**Addendum**

Mahopac Central School District  
Mahopac, New York

Reconstruction at  
Mahopac High School  
Mahopac Middle School  
Mahopac Falls Schools  
Bus Garage  
New Pump House

BID Addendum No. 2  
to  
Drawings and Project Manual

1 Single Line Diagram  
NTS

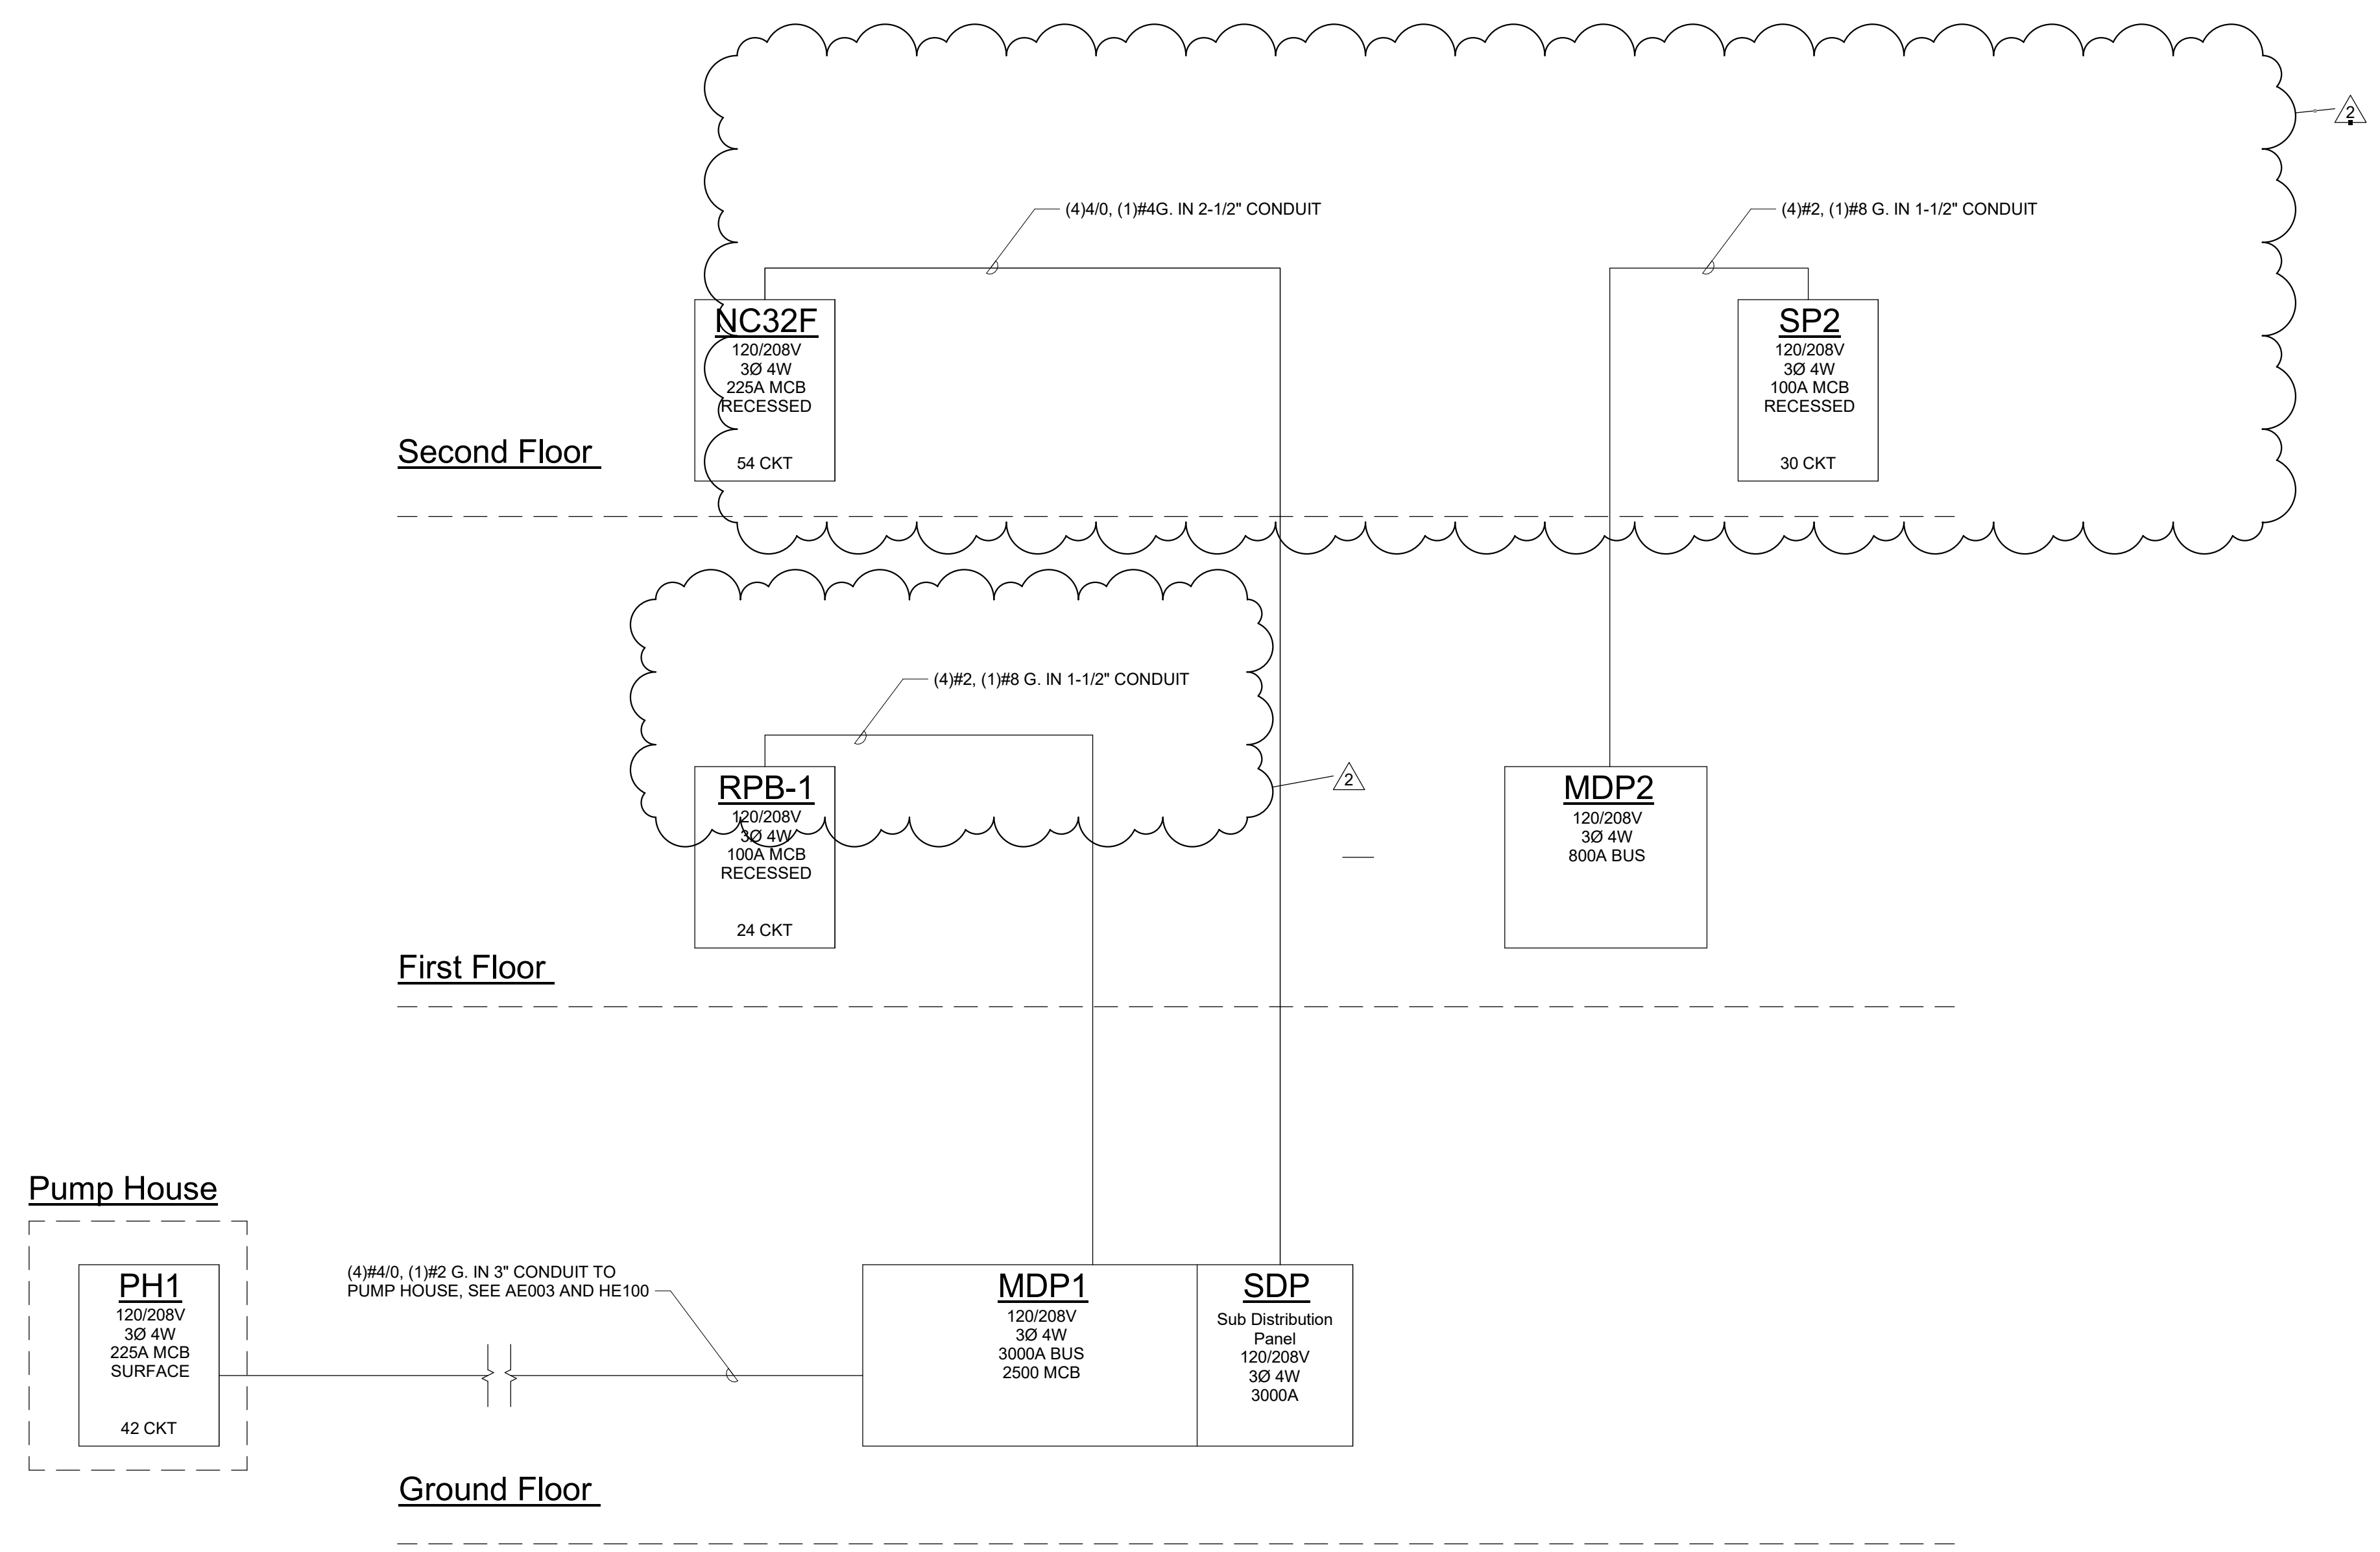
ITEM 2-C-13: Refer to DRAWING AE700

1. DELETE drawing in its entirety and, ADD new drawing attached to this addendum.

[On AE700 the new feeders all say that the panels are 3 phase 4 wire, yet you describe \(3\) conductors' and a Ground, Should all of these state \(4\) wires of the feeder sizes and a Ground?](#)

[REFER TO BID ADDENDUM NO 2](#)
